CROCKETT COGENERATION PROJECT
(92-AFC-1C)

PETITION TO AMEND
THE CALIFORNIA ENERGY COMMISSION
FINAL DECISION

SUPPLEMENTAL DATA
SUBMITTED JANUARY 12-20, 2012

MICRO PILE DETAIL

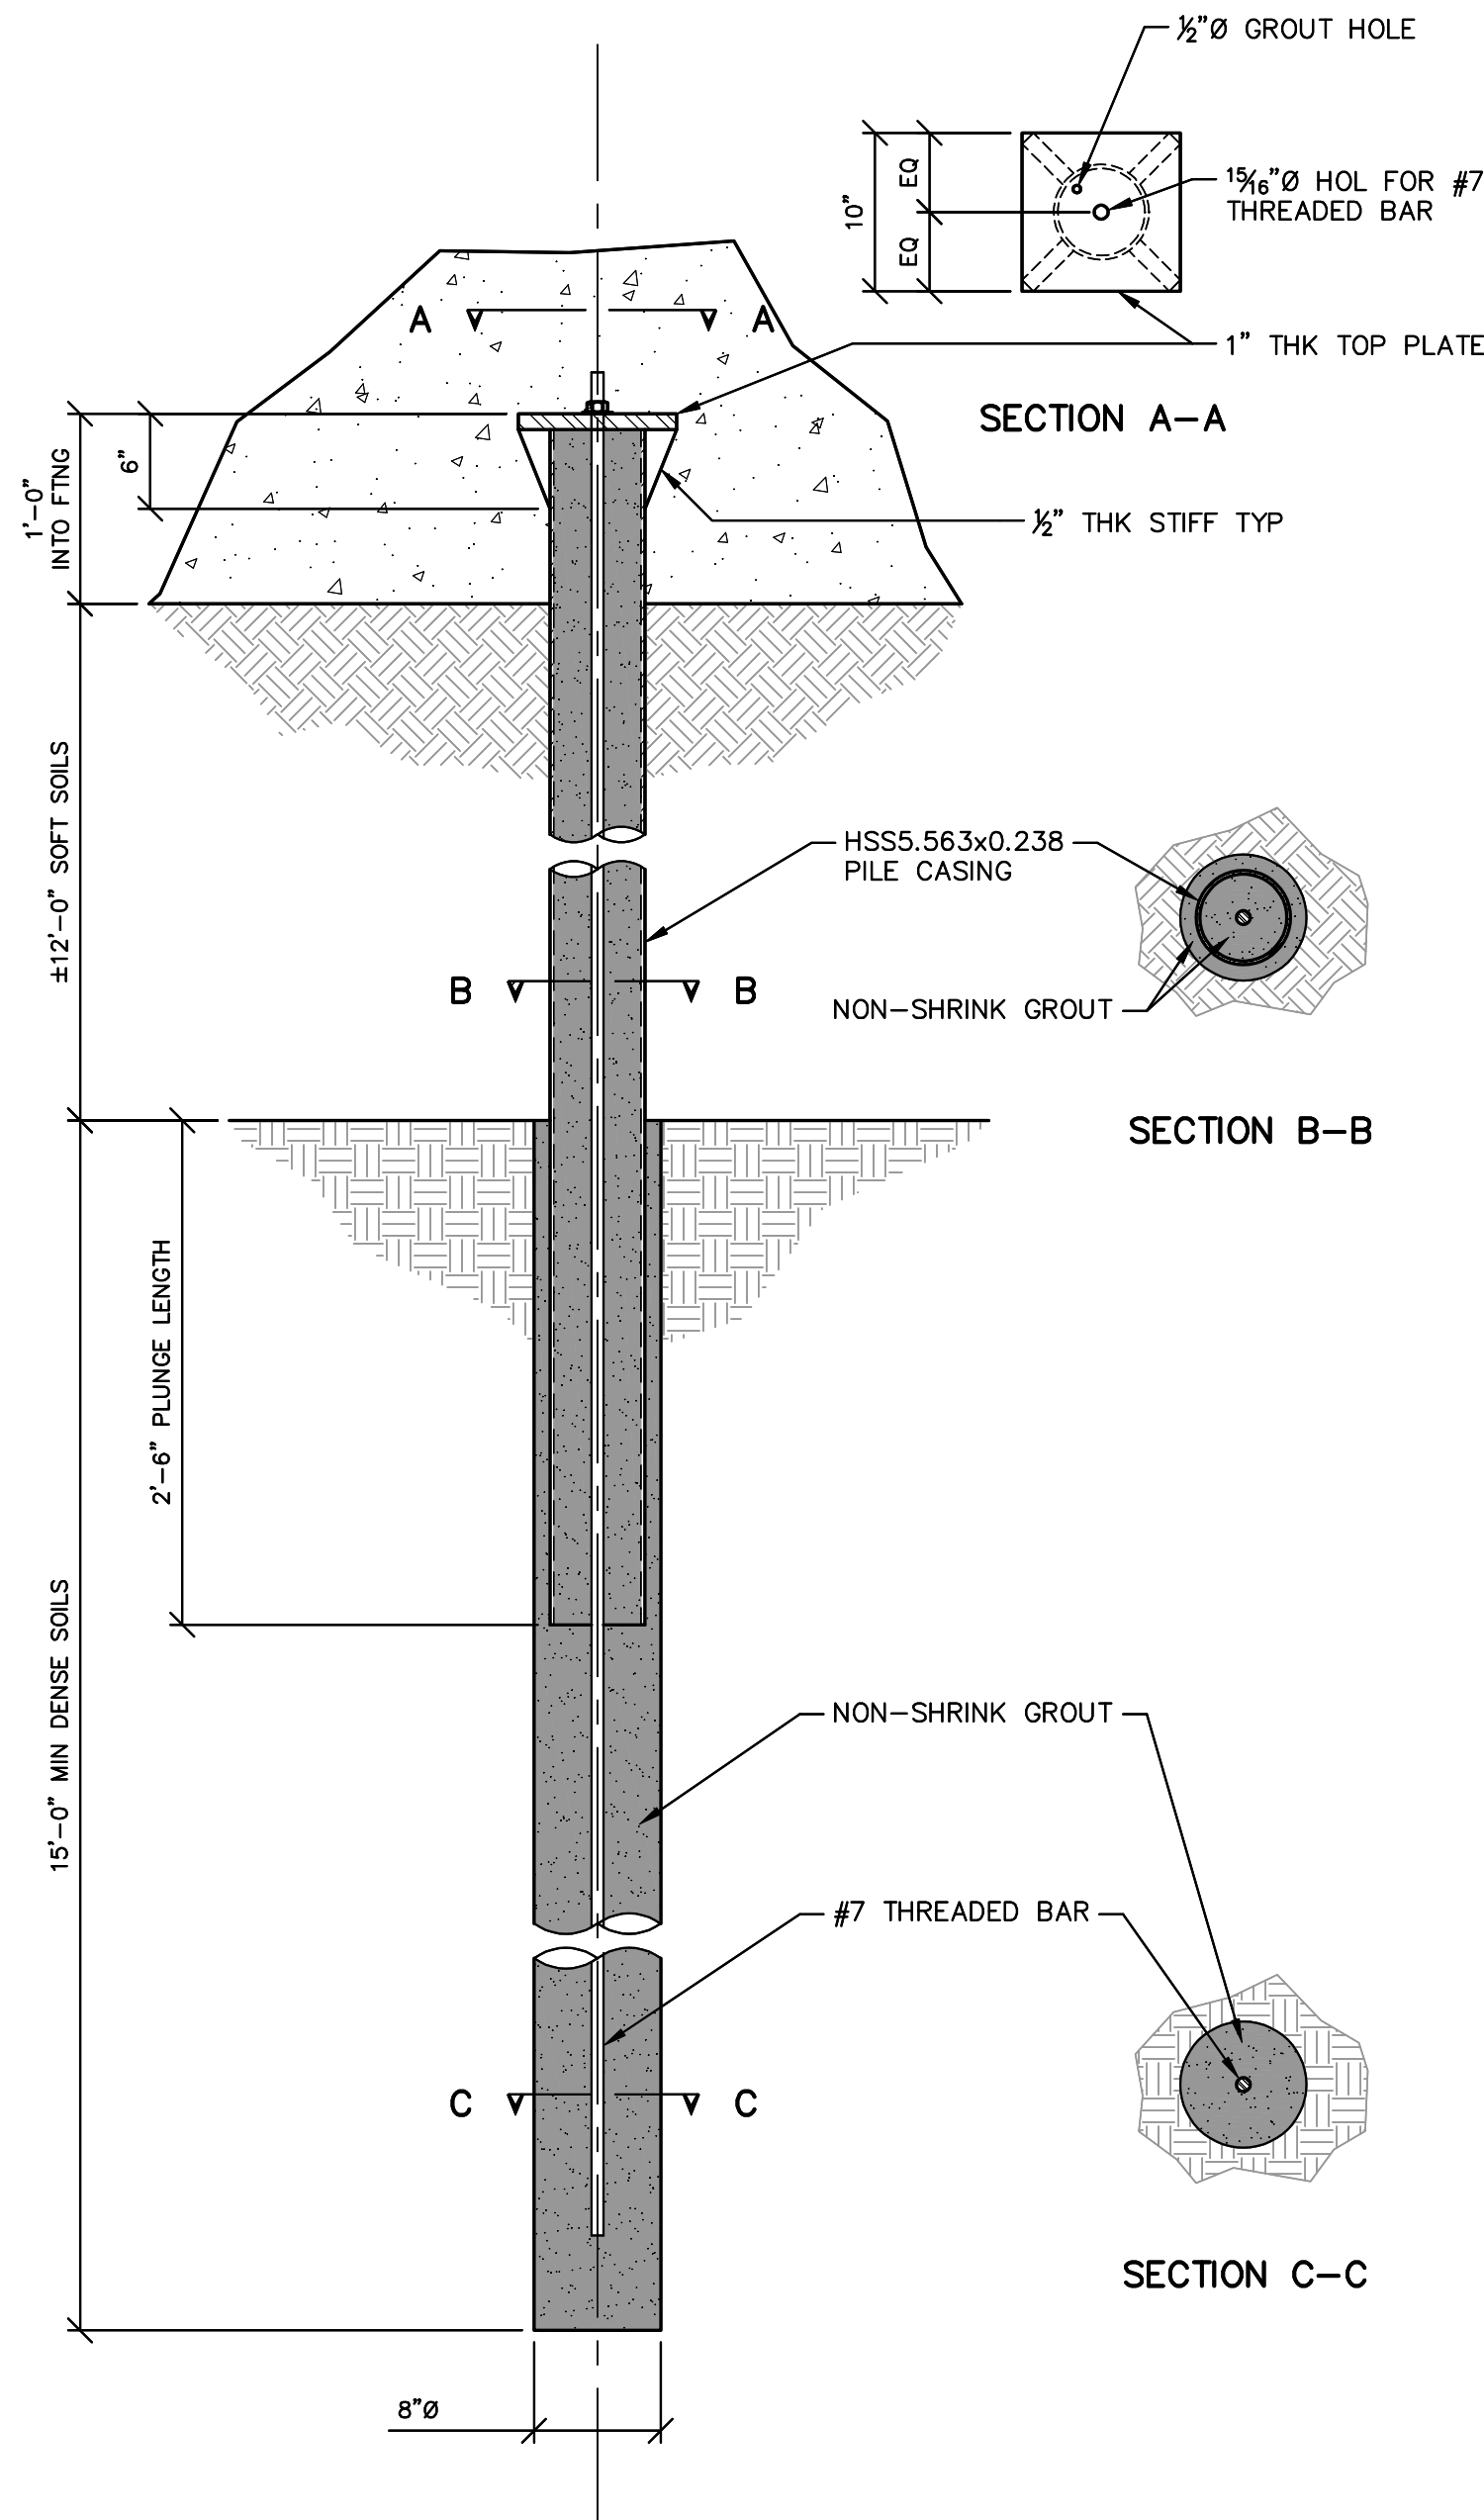
Question Geo-3: Please provide the following:

- 1) a detailed description of the "micro piles"
- 2) the method of installation of the micro piles
- 3) whether or not the micro piles will extend into stiff native soils
- 4) whether or not the micro piles are to be constructed in drill borings
- 5) address provision of information for soil characterization and subsequent disposal methods of the drillspoils (as applicable).

- 1) No micro piles will be used in the chosen foundation. The foundation will be Option 2 detailed on drawing S2.15. Project owner should get final foundation drawings from Project owner's engineering consultant, Cannon Corp., by January 27, 2012.
- 2) N/A. See response to question 1, above.
- 3) N/A. See response to question 1, above.
- 4) N/A. See response to question 1, above.
- 5) Amec, the project owner's geotechnical consultant, has been contracted to do boring, sampling and testing of the existing soil for waste characterization in the event that some of the soil needs to be landfilled. In the event that excavated soil needs to be landfilled, if such soil is determined to be hazardous it will be sent to US Ecology, Inc.'s Hazardous Waste Treatment and Disposal Facility located in Beatty, Nevada.
